**ADDENDUM NO. I**

**DATE:** November 12, 2021  
**TO:** All Potential Proposers  
**FROM:** James McKeehan, Assistant Purchasing Agent, City of Knoxville  
**SUBJECT:** Addendum No. I to ITB - Traffic Signal Cantilever Supports  
**PROPOSALS TO BE OPENED:** December 6, 2021 at 11:00 am Eastern Time

DECORATIVE BASE

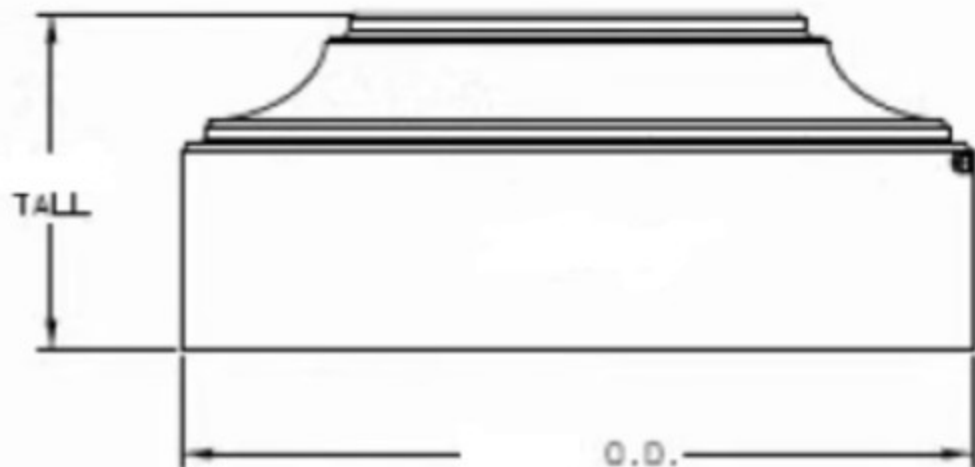
2. The Specifications state "Provide cast steel bases with removable cast iron covers for anchor bolts and tapped holes for attaching covers with hex head cap screws". Can you provide drawing of this cover?

3. Can this cover be aluminum or cast aluminum instead of cast iron?

**Response: Please refer to the drawing included in this addendum. Note that the dimensions of the base will change by the pole size. The drawing is a representation to match the other streetscape projects performed by the City.**

**Response: The material may be either aluminum, cast aluminum, or cast iron.**
